Interactive comment on “An innovative treatment concept for future drinking water production: fluidized ion exchange-ultrafiltration-nanofiltration-granular activated carbon filtration” by S. Li et al.

Received and published: 18 March 2009

Referee #1

Fig. 1. Rejection of micro pollutants after 3-day filtration and 4-day filtration.

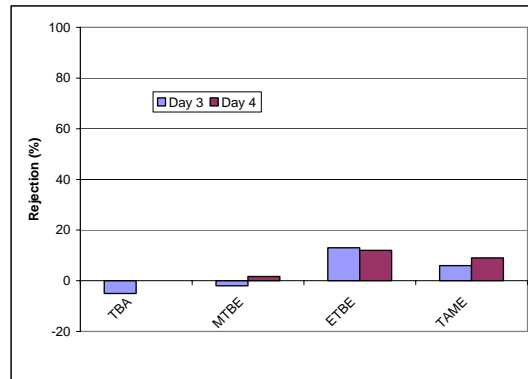
3. **Q:** The explanation of higher MTBE and TBA in NF permeate than NF feed is not reasonable.
A: Yes, we agree with the referee. The explanation of higher MTBE and TBA in NF permeate than in NF feed is not reasonable. After checking the raw data (Figure 1 in this file), the higher MTBE and TBA in NF permeate is due to the discrepancy of measurements and only one measurement listed in table. In the Table 3 of the manuscript, only the data of the left column in the following figure is listed. And we cannot explain exactly why there is a difference between two measurements.
